SSI:s granskning av SKB:s storregionala grundvattenmodellering för östra Småland
(SKB Rapport 06-64)

TITEL/TITLE: SSI:s granskning av SKB:s storregionala grundvattenmodellering för östra Småland (SKB Rapport 06-64/ SSI's review of the Swedish Nuclear Fuel and Waste Management Co's (SKB) report on large-scale groundwater flow modelling for eastern Småland in Sweden (SKB Report 06-64).

Technical Review for SSI of: "Storregional grundvattenmodellering –
 fördjupad analys av flödesförhållanden i östra Småland. Jämförelse av
olika konceptuella beskrivningar" by L.-O. Ericsson, J. Holmén, I. Rhén
and N. Blomquist, SKB R-06-64, May 2006.

Clifford I. Voss, U.S. Geological Survey
30 August 2006

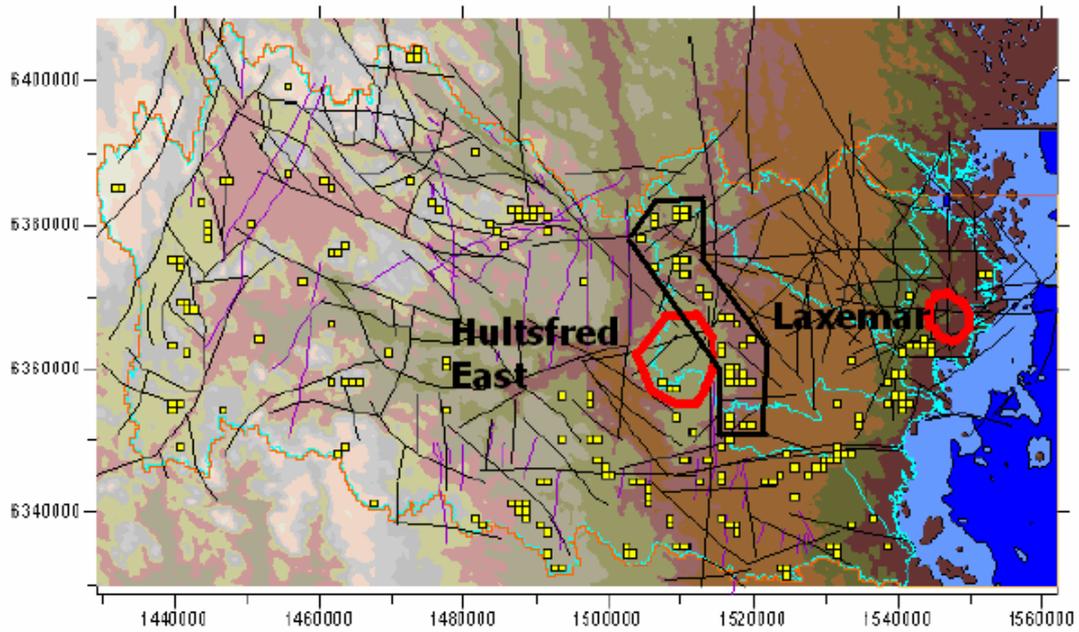
The current and previously-considered candidate repository sites are never shown on the maps presented in the subject report. I drew in approximate locations for Hultsfred and Laxemar sites (Figure 1) and compared these sites with key figures 7-1 through 7-9, of EHRB, which show the 'best locations' for the hydrogeologic parameters of importance, at least among some of the conceptual models preferred by the authors for the comparison. The best locations never occur in the Laxemar site, and some of the best locations are within or just east of the eastern margins of SKB's Hultsfred east candidate site of a few years ago.

One such cluster is in the Virån catchment, beginning in the north several kilometers east of Hultsfred and trending south-southeast for about 25 km (Figure 1). This cluster passes the eastern margins of the Hultsfred-east candidate site and all or part of this cluster appears in most of the selections of best sites shown in the report. Comparison with topography (Figure 2-3 of EHRB) and topographic gradient (Figure 4-3 of EHRB) maps shows that this cluster occurs within an elevated area of very low topographic gradient – a plateau. It should not be a surprise that repository sites below a broad smooth inland plateau would have longer flow paths, longer transport times and lower specific flux than other sites. Such areas of 'best sites' with many contiguous best locations would provide a robust region in which to locate a recharge-area repository with rather long paths lengths and travel times. In the cluster indicated in the figure, some contiguous groups of best locations cover areas of maybe 20 km^2, large enough for securely locating a repository within a region of good hydrogeologic properties with regard to subsurface flow. The authors present various combinations of '1000 best sites' in the above-mentioned figures but never present the type of interpretive discussion begun just above to elucidate the reasons for the locations of good sites.

Figure 2 – Locations of Site A (inland) and Laxemar (near coast).

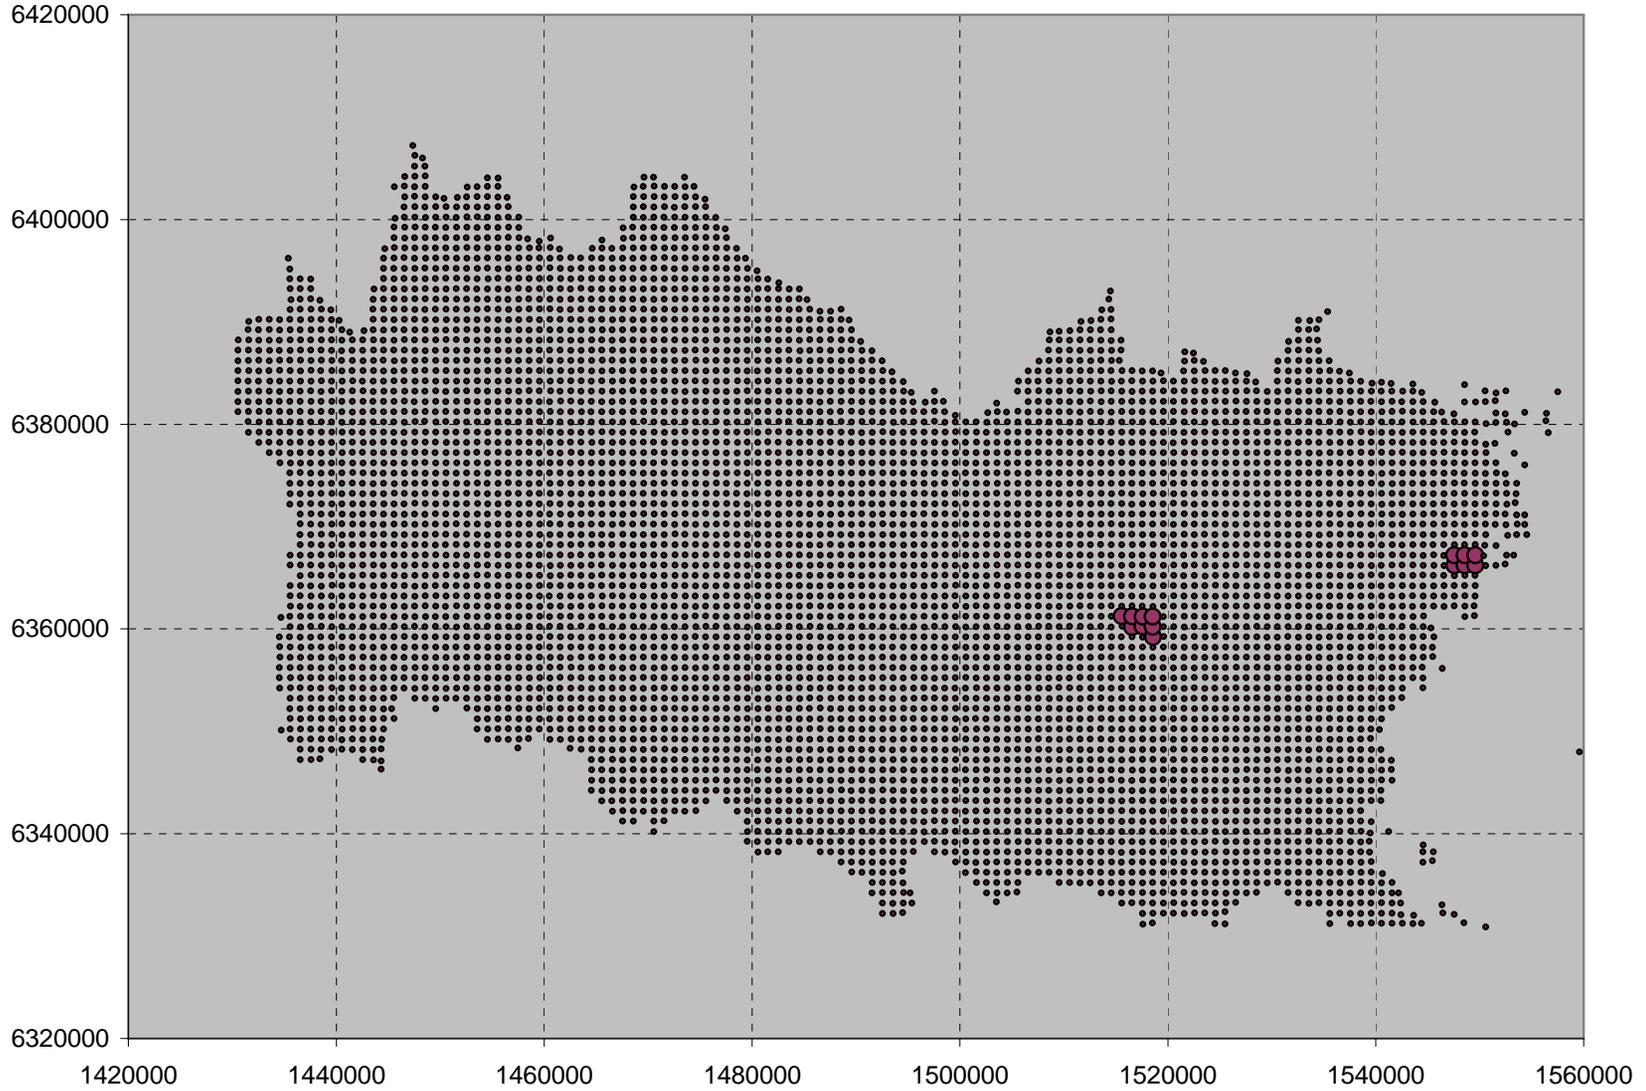
EXAMPLE COMPARISON SITE: SITE A
For example, I have illustrated results for one of the good sites found as described just above. I called it Site A. I believe it is just east of the Hultsfred east site considered a few years ago by SKB. Site A is also within the example region of interest for superior sites shown on Figure 1. In the EHRB report, some locations within Site A were also selected to be among the locations in the model area that have both the 1000 longest median paths and 1000 longest median times for two series of models (Series 2 in Figure 7-22, and Series 4 in Figure 7-23 of

EHRB). The actual location of this site does not matter here; the objective of this analysis is only to show that such sites can be identified using the type of analysis reported by EHRB, and that these may be better than Laxemar. Site A is only an example. The map of Site A and Laxemar is Figure 2. There is a small dot on the map for each block in the model and colored circles for the blocks within each site.

Site A consists of 8 contiguous blocks (8 km^2) and Laxemar consists of 6 blocks (6 km^2). (These 6 were picked by Prof. Anders Wörman, KTH, and me to fit completely within the site boundary, and most closely approximate the Laxemar site, given the discretization used in the modeling.) See Table 1 for coordinates.

Figure 3 – Visual comparison of each average statistic among all 7 model cases between Site A and Laxemar.

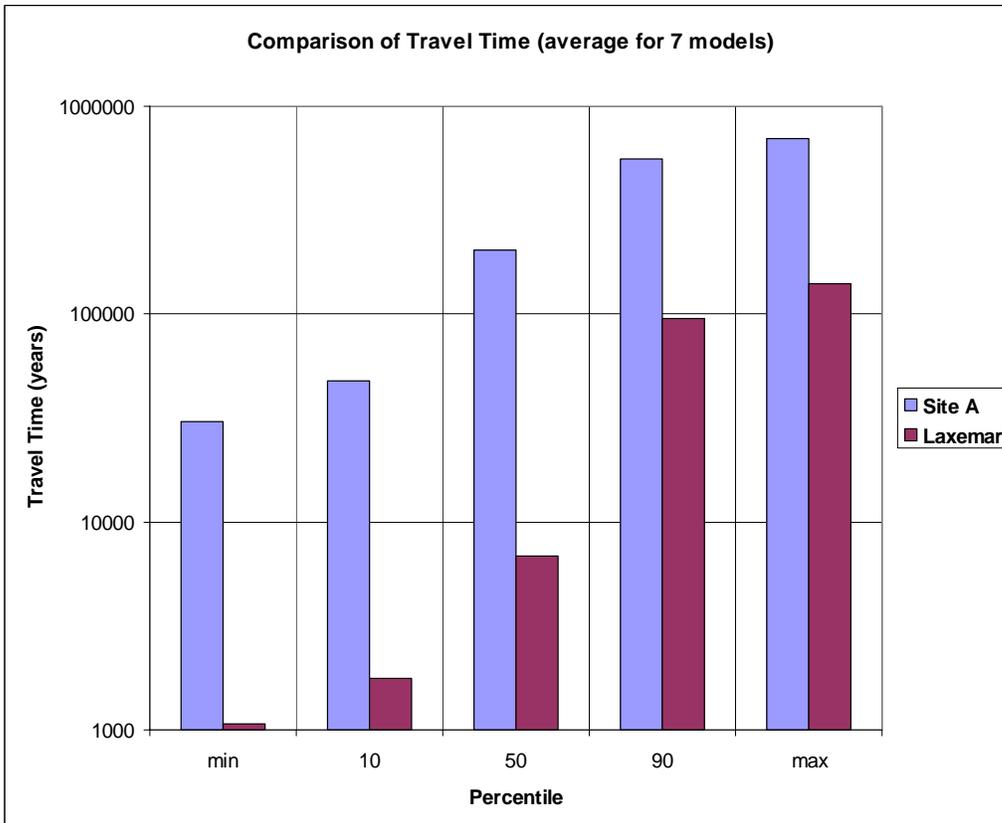
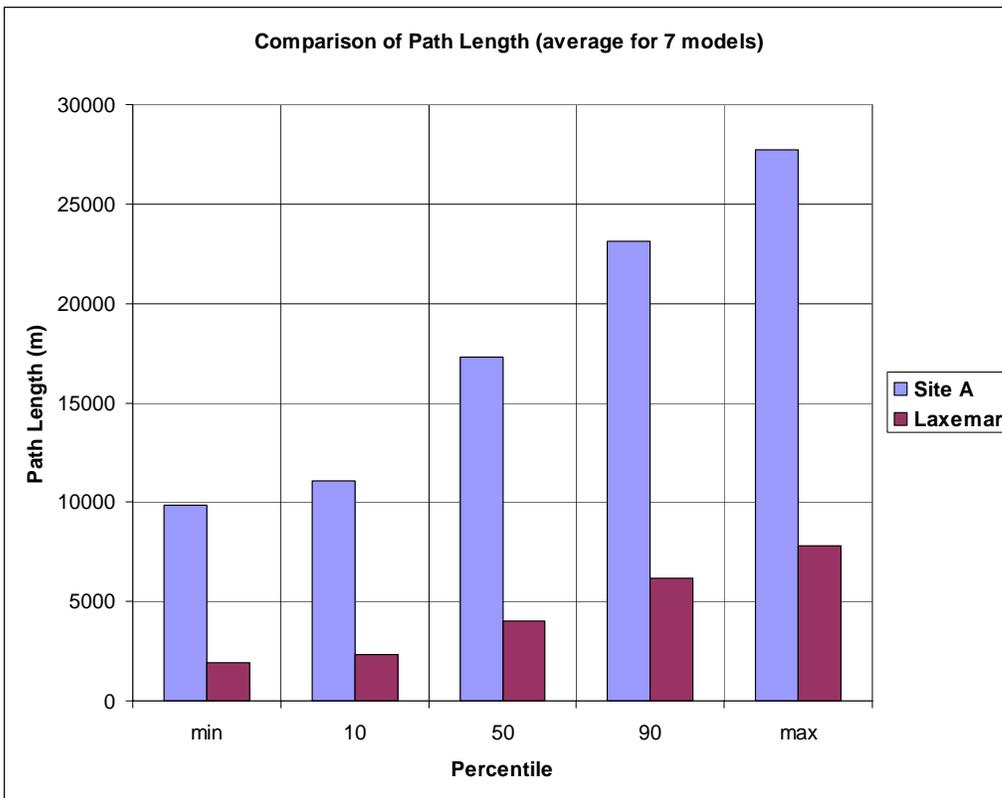
The bar charts of Figure 3 show the combined (average) value for all 7 models for each path length and travel time statistic for Site A and Laxemar. The charts show that Site A is superior to Laxemar for every combined path length statistic and for every combined travel time statistic. Site A combined path lengths range from 10 km to 28 km, in comparison with Laxemar lengths ranging from 2 km to 8 km. Site A combined travel times range from 30 ka to 700 ka, in comparison with Laxemar times ranging from 1 ka to 140 ka.
